**RE: 12<sup>th</sup> Street Road Diet (CPN 718780)**  
**Final Drainage Report**  
**Engineer's Stamp Date: 06/19/24**  
**Hydrology File: H13D120**

Based upon the information provided in your submittal received 06/19/2024, the Final Drainage Report is approved for Work Order.

**RE: 12<sup>th</sup> Street Road Diet (CPN 718780)**  
**Preliminary Drainage Report**  
**Engineer's Stamp Date: No Date**  
**Hydrology File: H13D120**

Based upon the information provided in your submittal received 03/12/2024, the Final Drainage Report **is not** approved for Work Order. The following comments need to be addressed for approval of the above referenced project:

Figure 3

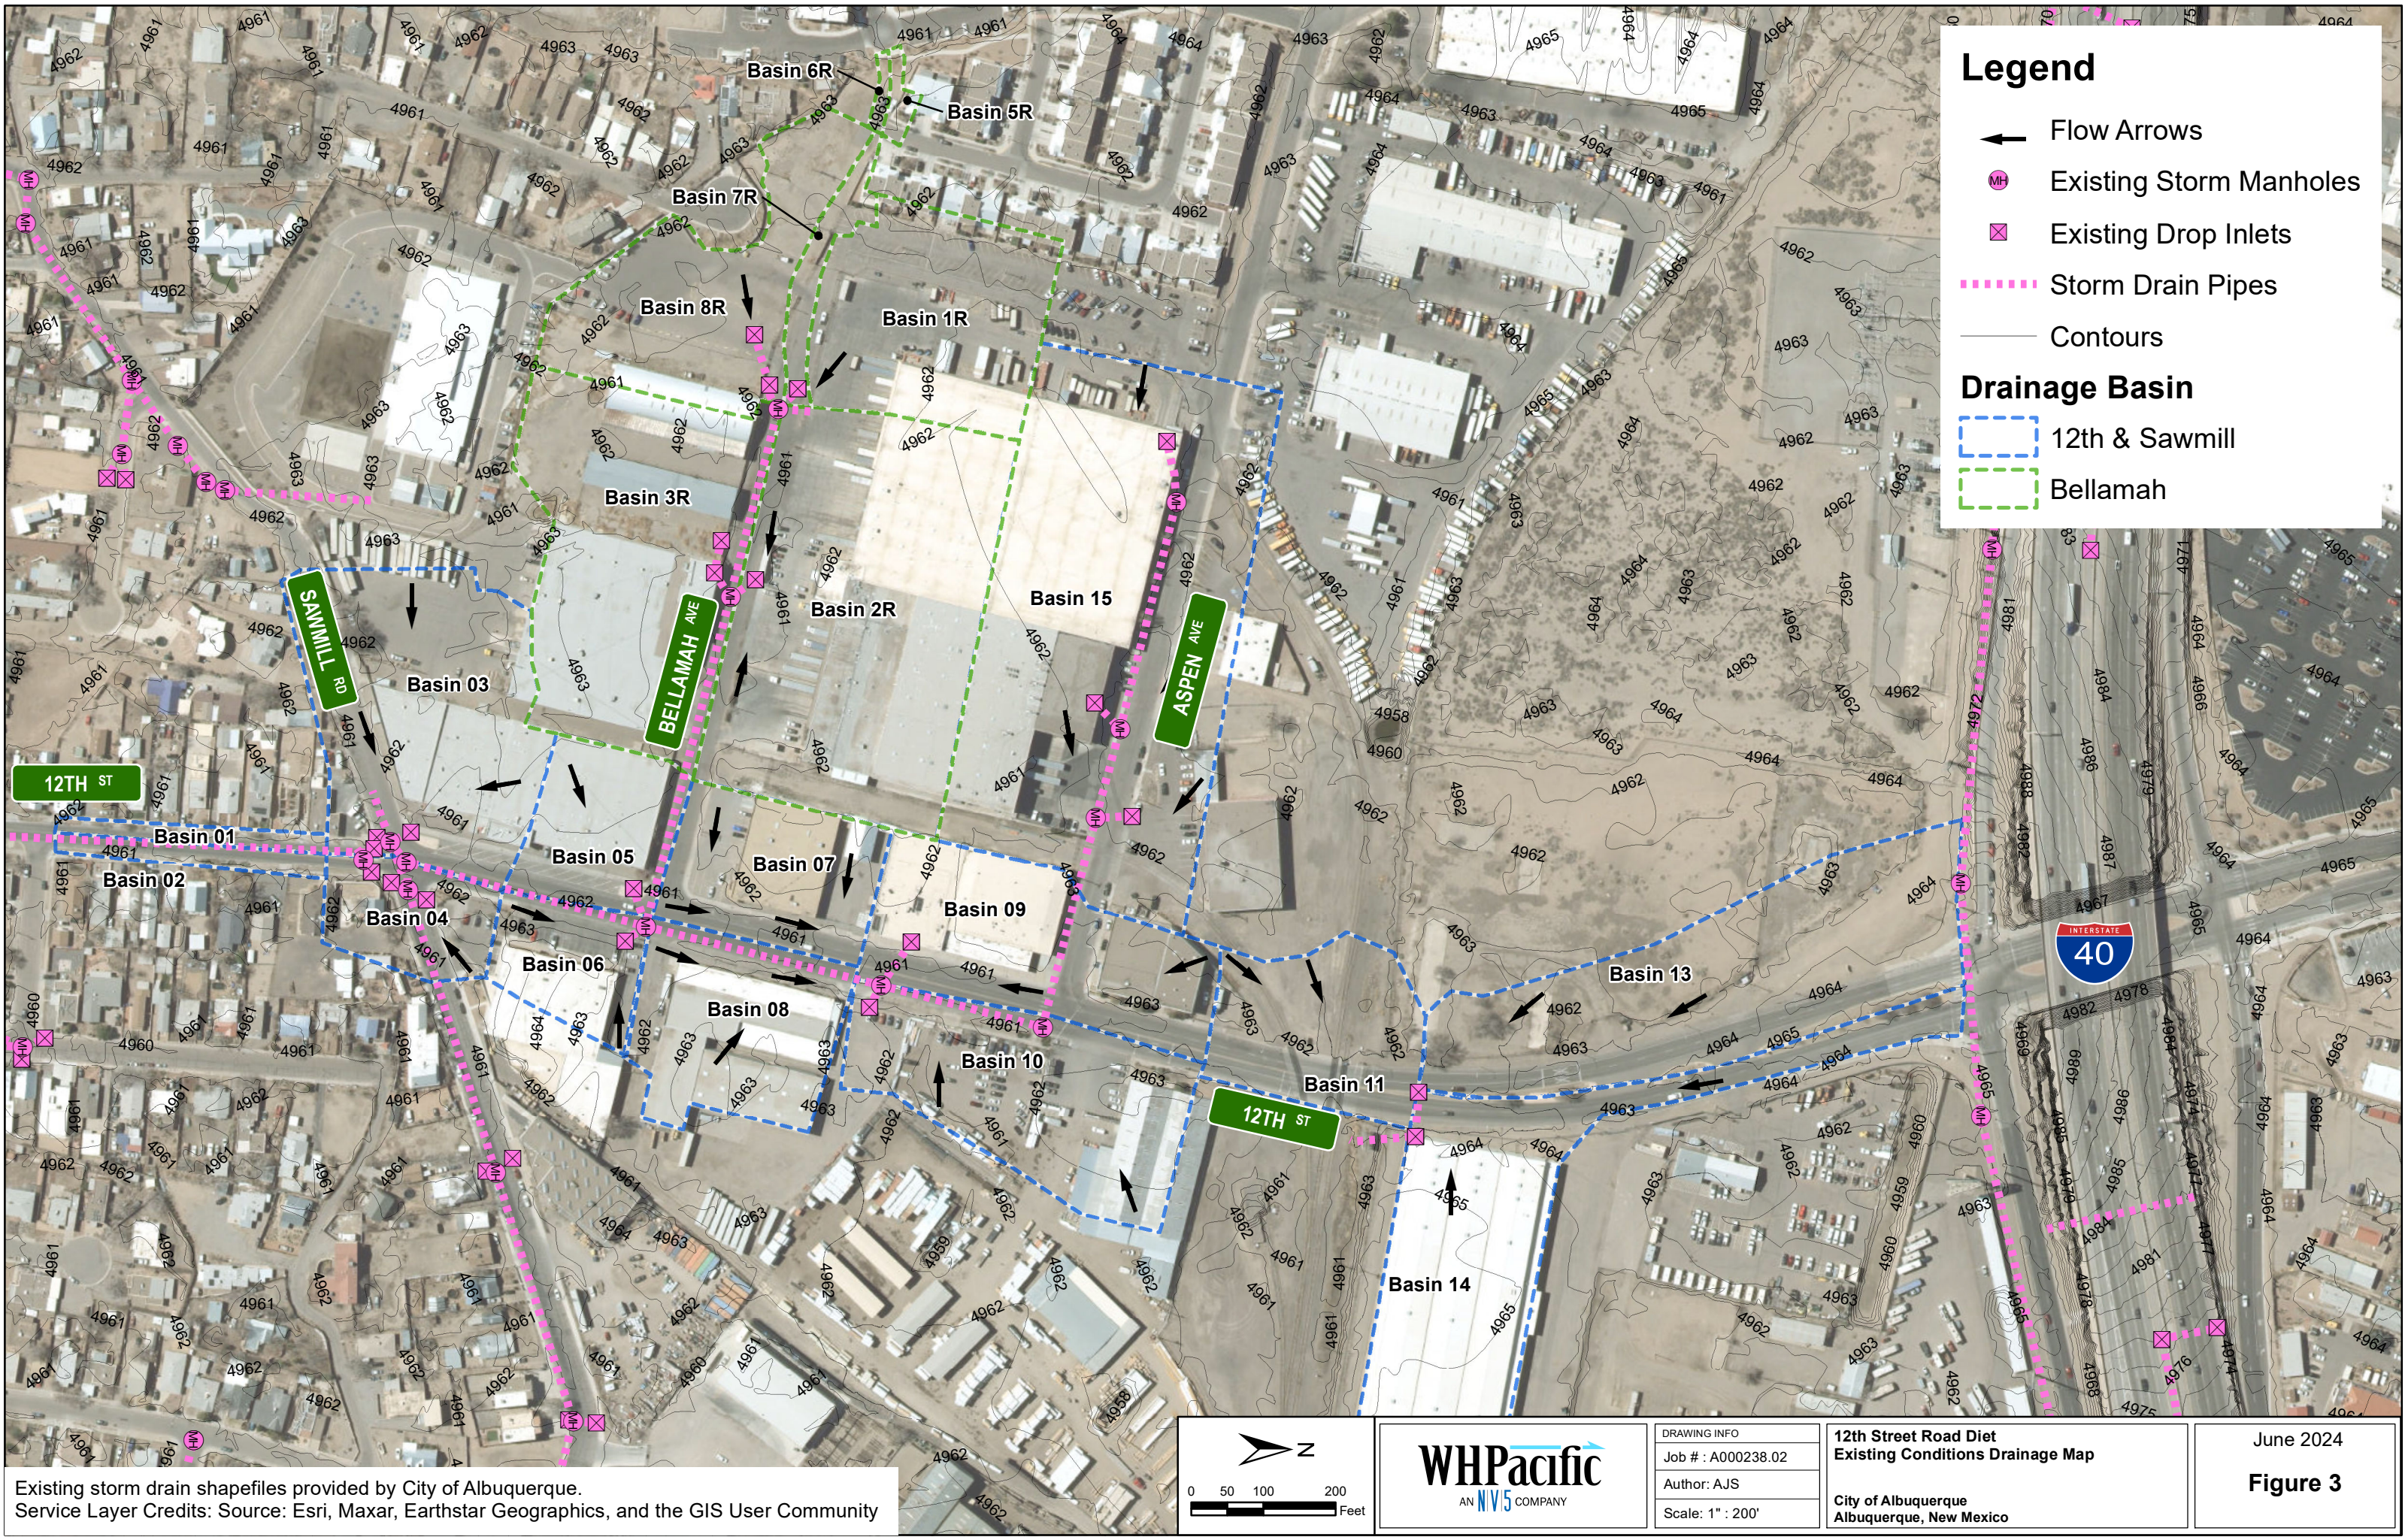
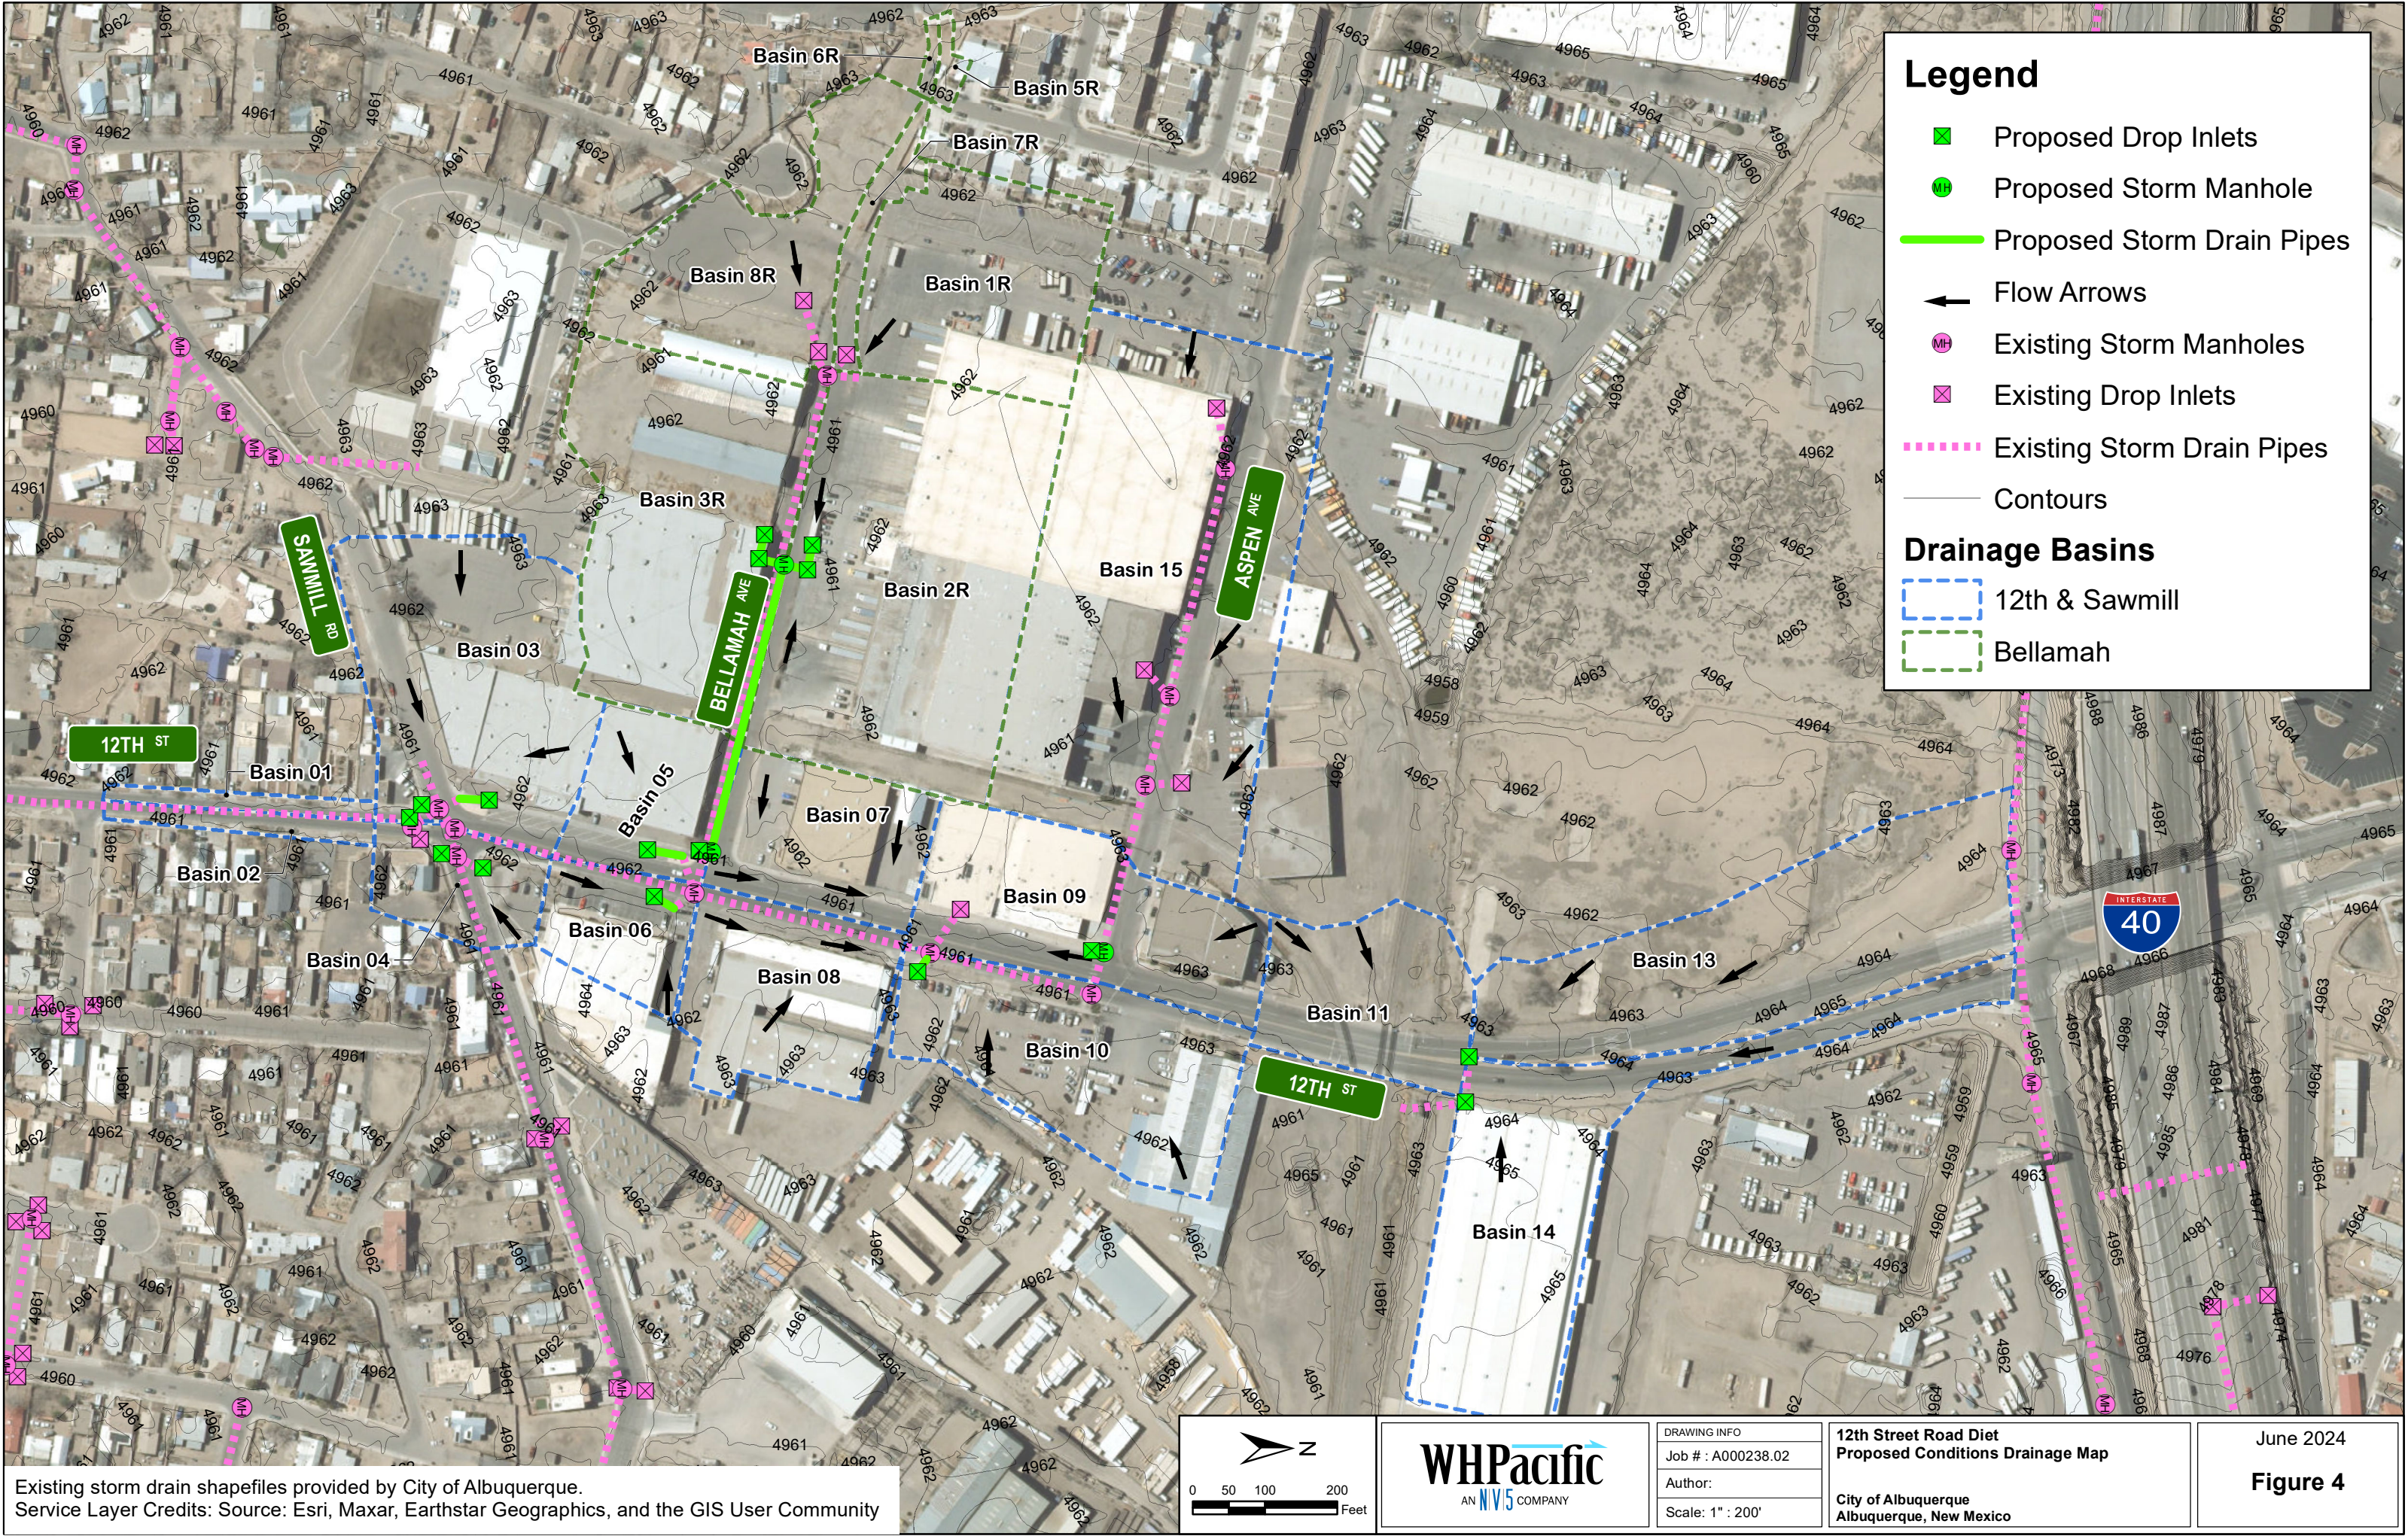
1. Please provide an engineer's stamp with a signature and date. **Done**
2. It appears that the drainage area for Bellamah Ave is missing in both the existing conditions and proposed conditions drainage maps. **The Bellamah storm water flow rate had been taken from the 60% design for and included in this analysis, but that was not evident in this report. The drainage basins and hydrology from the Preliminary Drainage Report prepared for Bellamah (City Project 7703.72) have now been included on the basin map and hydrology. The storm runoff from Bellamah is included in the 12th Street storm drain. The basin divide is correct as shown in Basin 05 which is a high point in Bellamah Avenue – stormwater flows from the basin 5 divide west to a small sag in Bellamah Avenue that will be held in the future roadway improvement design. See revised figures and additional hydrology added in the Appendix.**
